PRODUCT CHANGE NOTIFICATION

Bourns® Model SRP0735EA Series Shielded Power Inductors *Implementation of Multiple Changes*

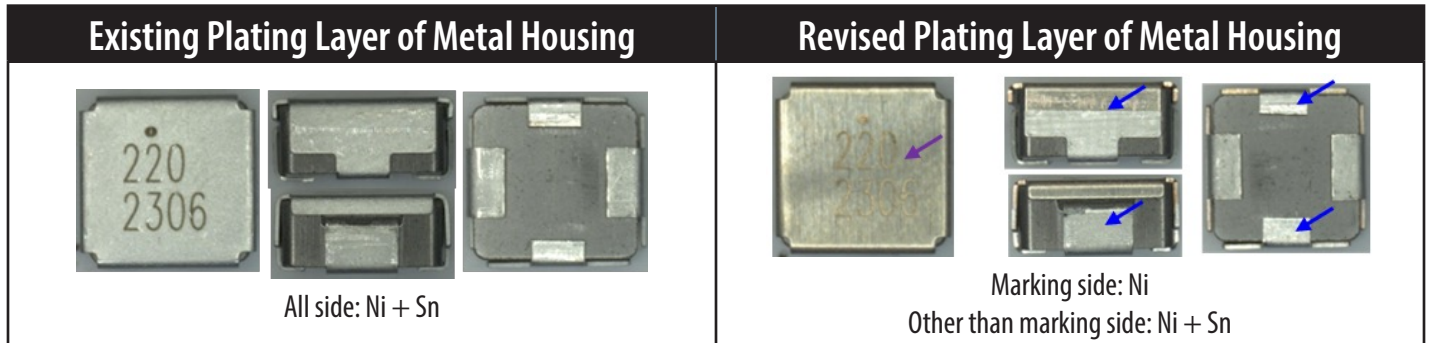
Riverside, California - February 9, 2024 – As part of our continuous improvement efforts, effective August 15, 2024, Bourns will change the bottom, case design and the supplier of the case for the Model SRP0735EA Series Shielded Power Inductors. The modified bottom has a winding start point and groove, and the dimensions of the case edge have been adjusted. Additionally, the plating layer of the metal housing has been modified. The additional supplier has been qualified and is included in the Authorized Vendor List. A list of affected part numbers is included below.

As shown in the images above, the form and fit of the affected part numbers will change slightly due to the design changes. The function of the affected part numbers will remain the same. The quality and reliability of the affected models should be improved. Traceability will be maintained through lot code and date code.
